# Access Compliance Report

## Public Rights-of-Way

### (Curb Ramps)

Intersection ID: N/A	Main Street: BALLANTYNE CORPORATE PL	Cross Street: N/A	Location: NW
ADA ID: E8D4475A3430	Ramp Type: Directional	Initial Pass/Fail: Fail	Overall Compliance: No
Severity Score: 10			
Codes/Mitigation Info/Possible Solution		Field Measurements/Component Compliance

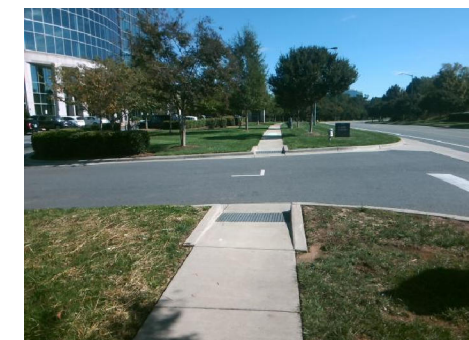
**R304.5.1, R304.5.3**

**Remove & Replace Entire Ramp.**
